TENNESSEE VALLEY AUTHORITY

December 5, 1986

WATTS BAR NUCLEAR PLANT - RESPONSE TO NRC WELDING QUESTIONS - YOUNGBLOOD TO WHITE, DATED JULY 24, 1986 AND VOLLMER TO WHITE, DATED OCTOBER 14, 1986

Figure 1. Assessment and Disposition.

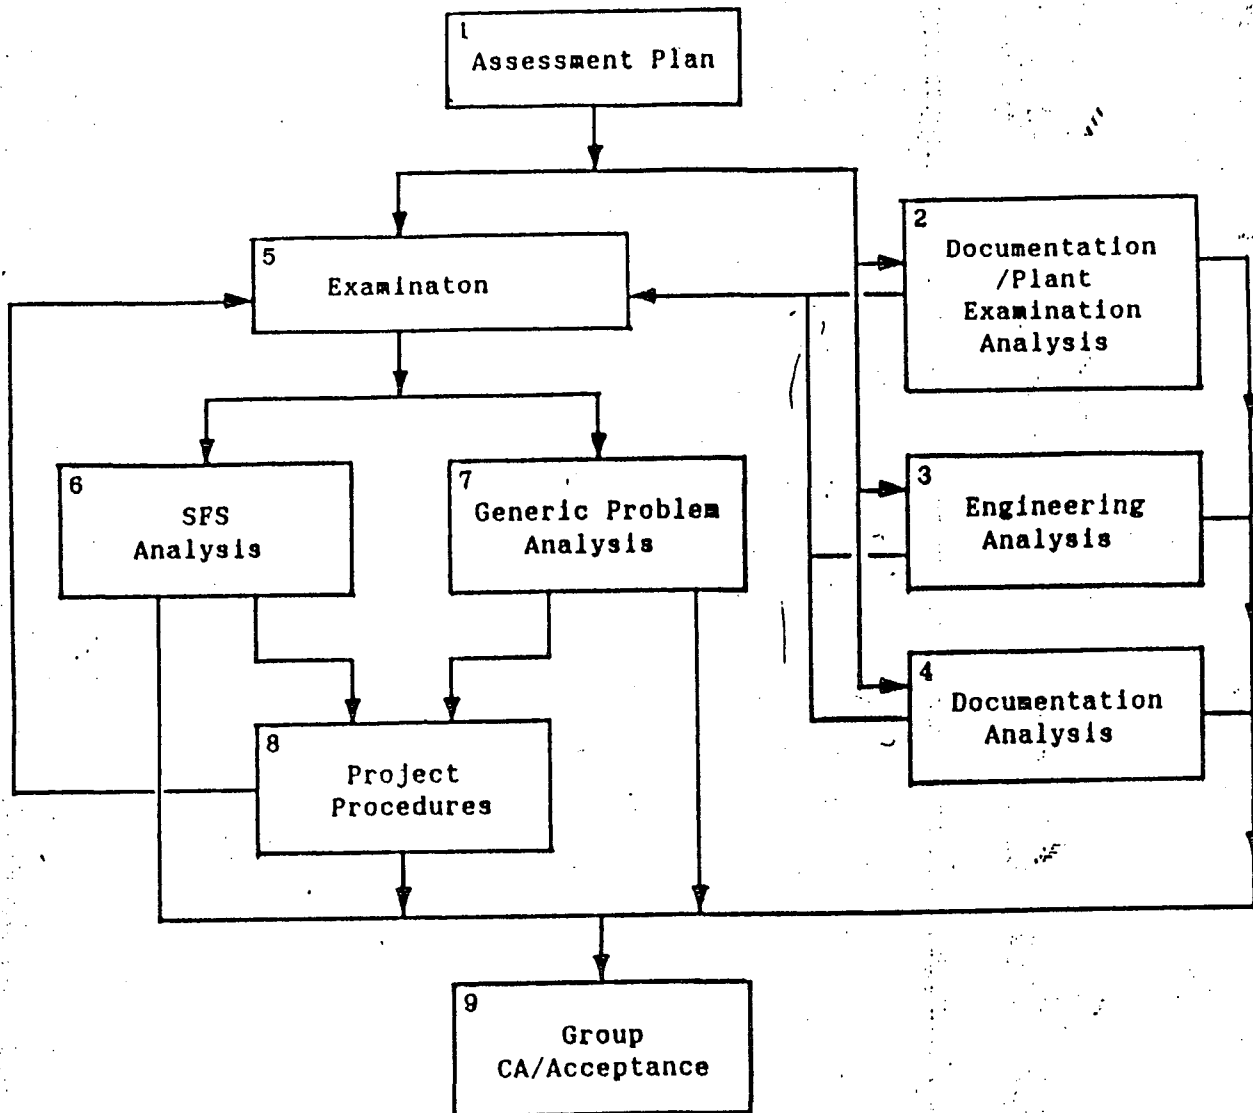
2. Your handouts for the June 25 meeting provided flowcharts for assessment and disposition, multiple sampling plans, generic problem analysis, project procedures, etc. Provide a full description of each "logic block" and its relationship to preceding and following blocks. In addition, provide an example of the operation of the block with a specific problem. In particular, discuss the conditions that would result in an expansion of the sample size and the conditions that would result in 100% reinspection of given population.

- o Figure 1, "Assessment and Disposition," shows the general steps taken to evaluate weld quality issues, to disposition any associated deviations, and to resolve these issues. A block displaying "Project Procedures" (Block 8) was added for completeness. A block displaying "Group CA/Acceptance" (Block 9) replaces two previous blocks labeled "Corrective Action" and "EC/QI Closure".
